PRE-BID CLARIFICATION FORM

PROJECT NAME:		FILLMORE HIGH SCHOOL NEW ATHLETIC COMPLEX	
PROJECT NUMBER:		Project No. 2024-017 / DSA #03-123950	
TO:		RJ Stump EMAIL: rj.stump@fillmoreusd.org Fillmore Unified School Dist. Roy Frey WestGroup Designs royf@westgroupdesigns.com	
DATE:	February 5, 2025		
FROM:	Icon West, Inc. 520 S. La Fayette Park Pl, Suite 503 Los Angeles, CA 90057	EMAIL:	felix@icon-west.com
DOCUMENT/DIVISION NUMBER:		DRAWING NUMBER:	Base Bid - A2-2.2, Solar / Battery

REQUESTED CLARIFICATION: #35

E2-2.2

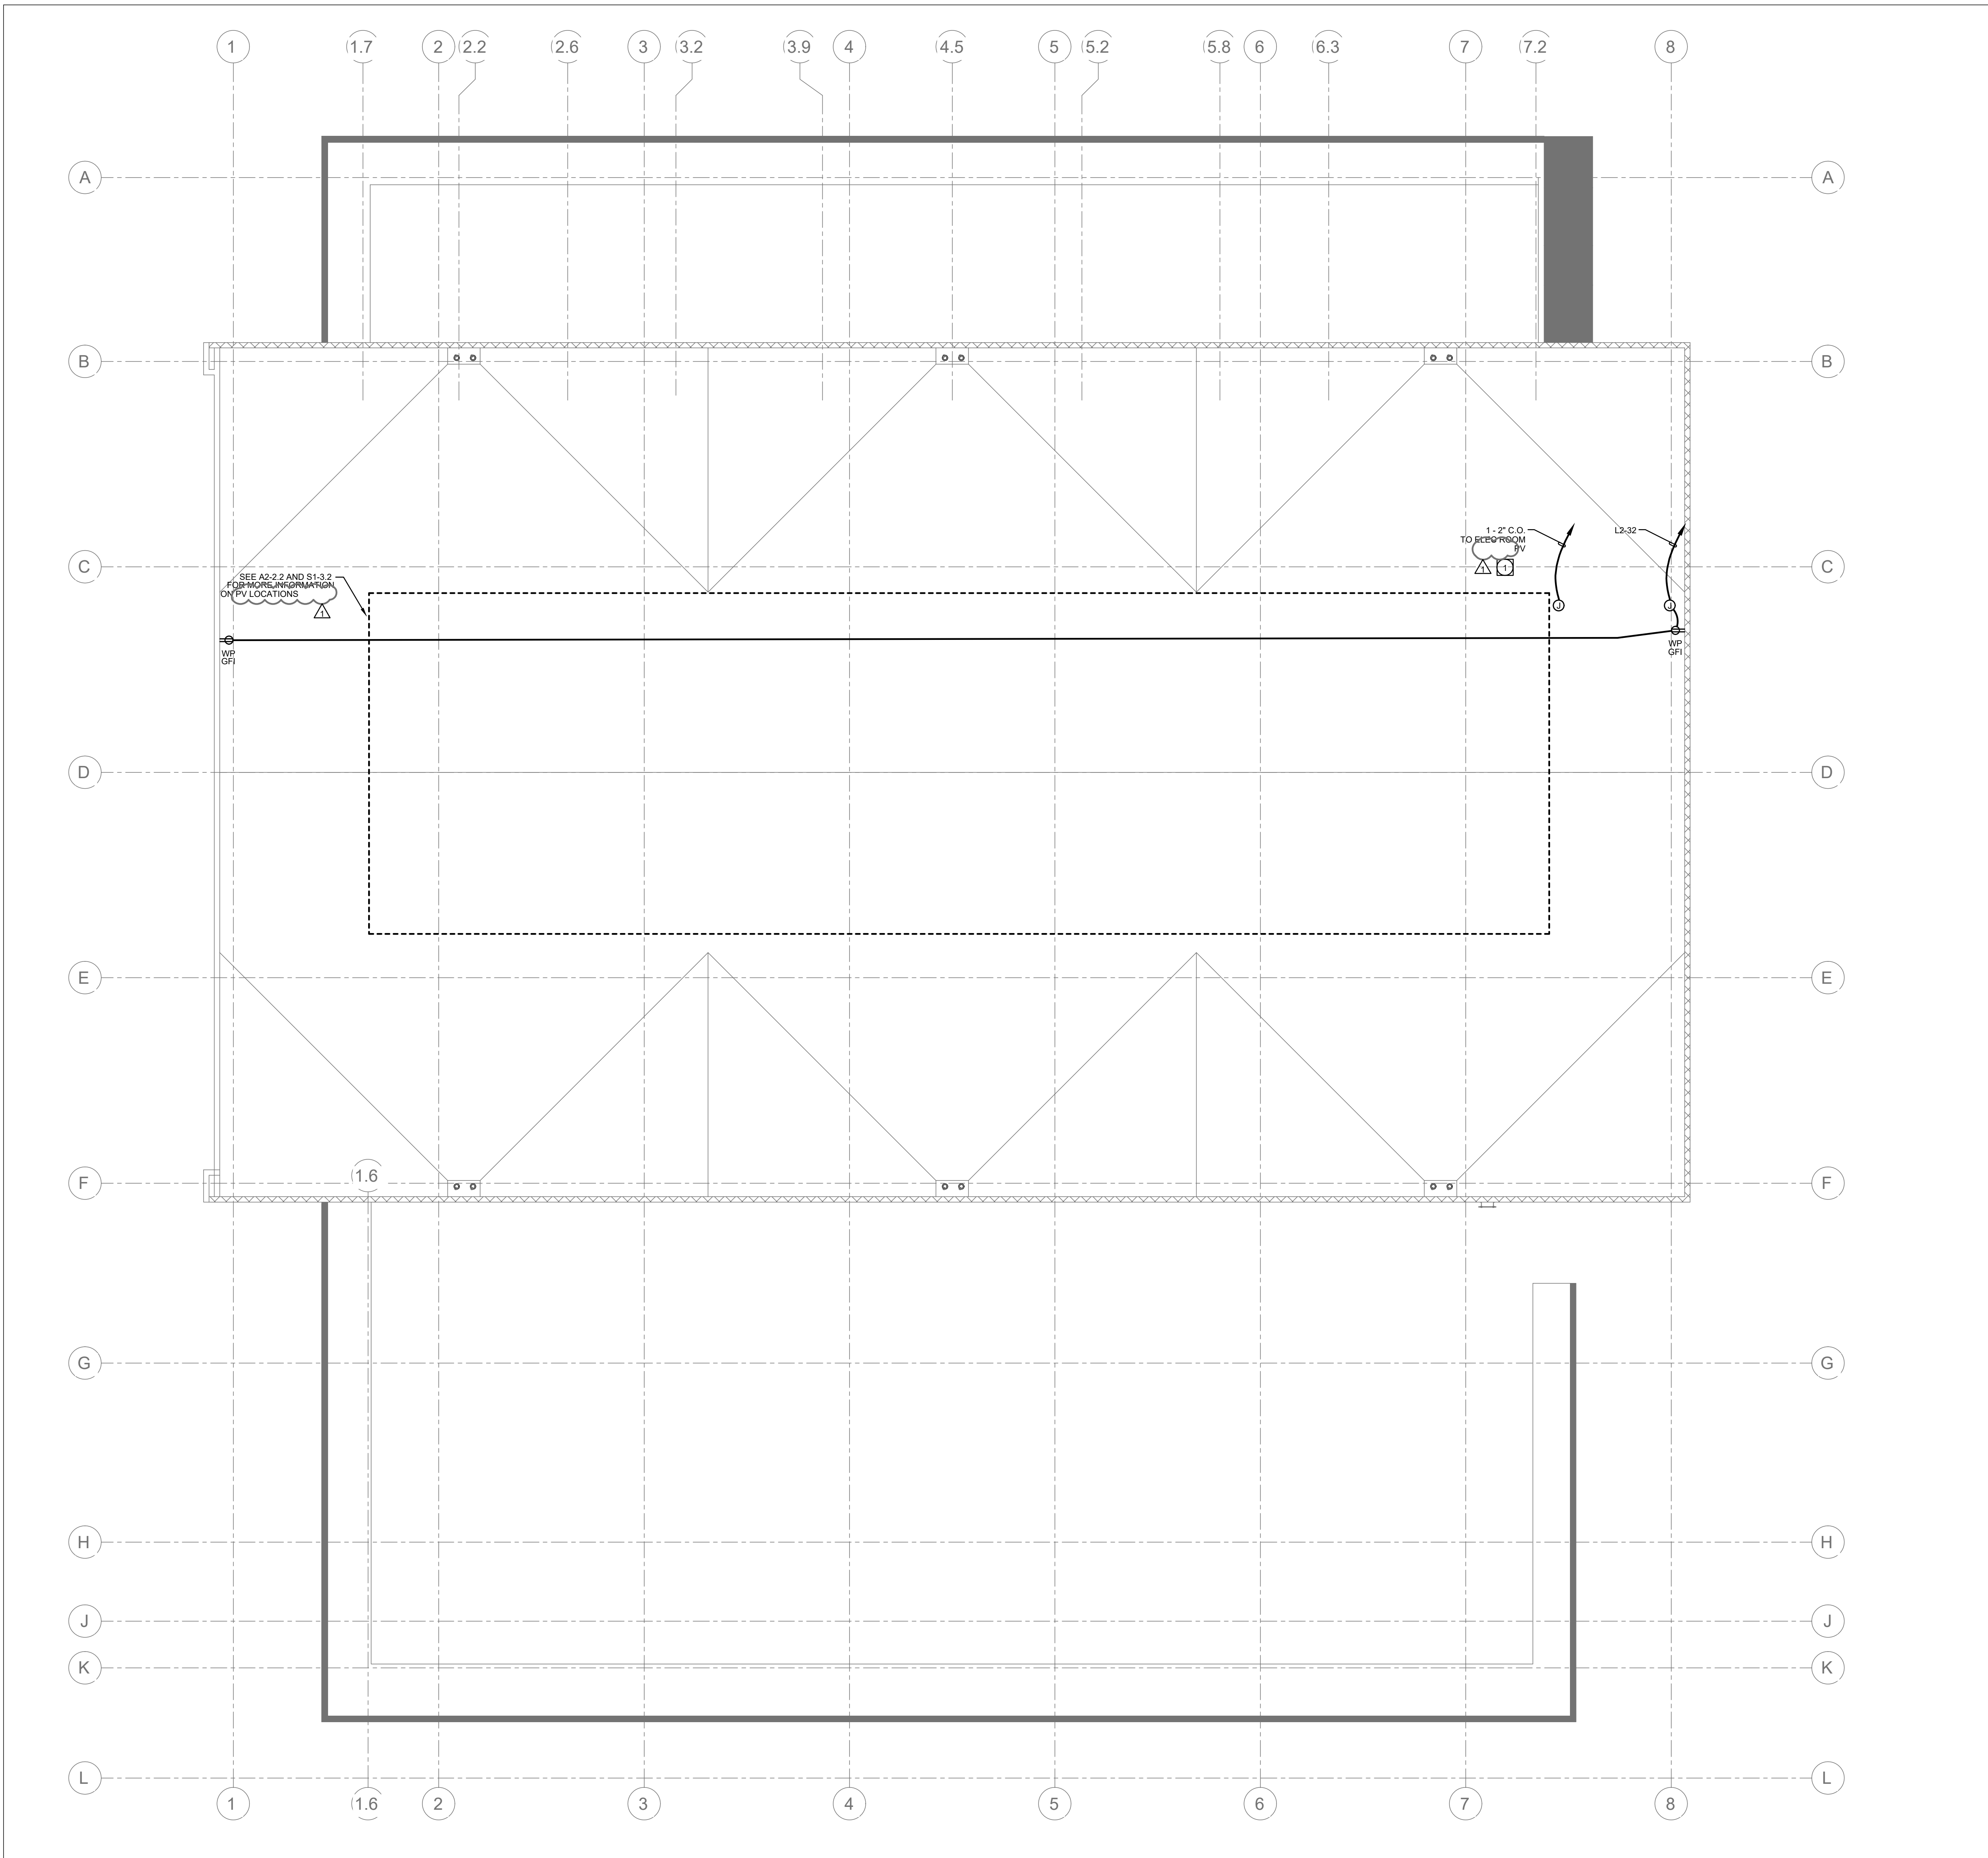
The layout shown does not provide reference to panel wattage / brand type. Additionally, is there a request for batteries & specific sizing for those units? Please advise.

Layout shown is just for structural connections and rough panel layout. Contractor to provide a fully designed PV system that meets the criteria stated on E2-2-2. See attached sheet E002 for Battery sizing and conduits required.

PLAN NOTE:
SECTION 140.10 CALCS
KWpdc = 72.17 kW
KWbat = 161.30 kWh
KWbat = 33.2 kWdc
PV SYSTEM SHALL BE MINIMUM 72.27kW
FOR COMPLIANCE 140 PANEL LAYOUT
SHOWN ON A2-2.2 AND S1-3.2
